BLUE BIRD

R11TA

SUBJECT: RECALL R11TA STARTER CABLE MAY CONTACT POWER STEERING HOSE

Starter Cable May Contact Power Steering Hose

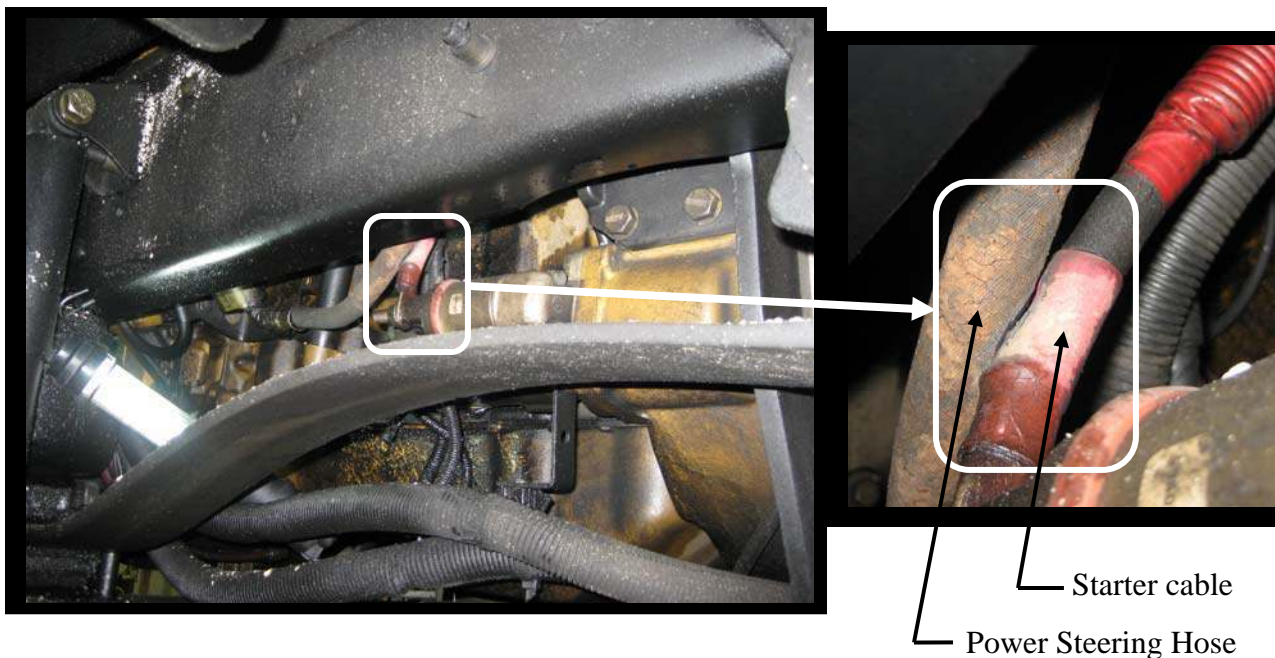
The starter cable may contact and potentially chafe against the steel braided power steering hose thereby creating a direct short which could result in a fire.

1. Park the bus on a level surface, apply parking brake, and remove ignition key and chock wheels.
2. Disconnect Batteries: Note when disconnecting the batteries, remove the Negative cable first.
3. On lower left side (driver's) of engine; inspect the positive starter cable and power steering hose for possible contact as shown below.

Inspect for proper clearance between the starter cable and the power steering hose. If insufficient clearance is found, install a clamp to prevent further contact. Any damaged power steering hoses or starter cables must be replaced.

Install dual swivel saddle mount and cable ties.

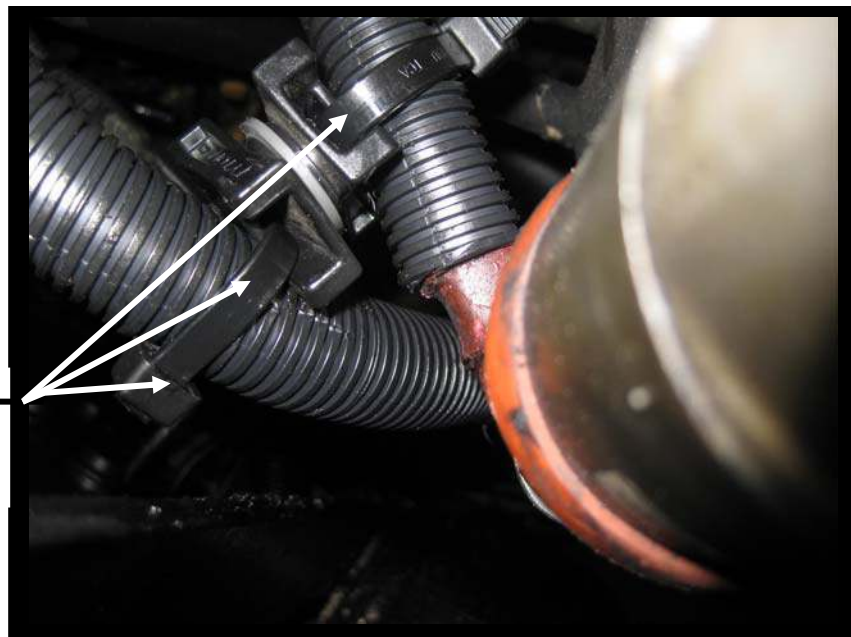
4. If the starter cable has contacted the power steering hose, separate and inspect both for any possible damage. If either has been damaged, contact Blue Bird Recall Administrator for a replacement.
5. If there is no contact and a minimum of one (1) inch clearance between the starter cable and power steering hose, no further action is required.
6. If there less than one (1) inch clearance, install a dual swivel saddle mount and two cables ties between the power steering hose and starter cable and secure with two cable ties.
